Opinion on Energy Imbalance Market (EIM) Resource Sufficiency Evaluation Enhancements

Members of the Market Surveillance Committee of the California ISO

February 2, 2022

Figure 1. CAISO Flexiramp Requirements 2015. (Source: California ISO, Department of Market Monitoring, Q2 2015 Report on Market Issues and Performance, August 17, 2015, Figure 2.4, p. 44)

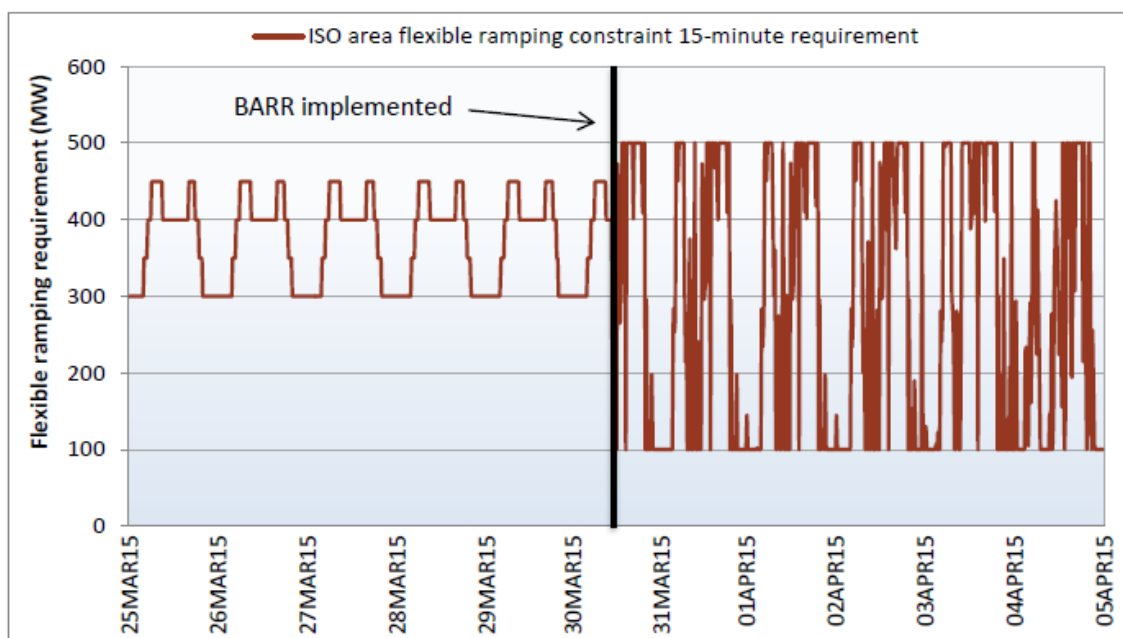
The impact of small sample size on the variability of estimates of the tail of a distribution is well illustrated by a graphic DMM prepared in 2015 to illustrate this point. The graphic portrays the variations in the CAISO flexible ramping required estimated using the BARR tool, which looked back over a limited number of intervals. The graphic shows clearly how the estimate swung back from the cap to the floor as small numbers of data points entered and exited the sampling period.¹¹ The number of data points included in the sample has been increased since 2015, so this figure does not show the current variability of the uncertainty requirement, but our point still applies: the necessary compromise between statistical precision (from enlarging samples) and avoiding bias (from avoiding enlarging samples to include less relevant data) results in samples that are too small to yield stable and precise estimates of tails of distributions and, thus, the requirements based on those tables.

¹¹ For instance, comparing the hour-by-hour requirements for April 5, 2015, with March 31, 2015 in the figure shows large differences although the sampling window used to construct the histograms differed by only 6 days. The instability over hours within a day also is at least in part an artifact of sample error.
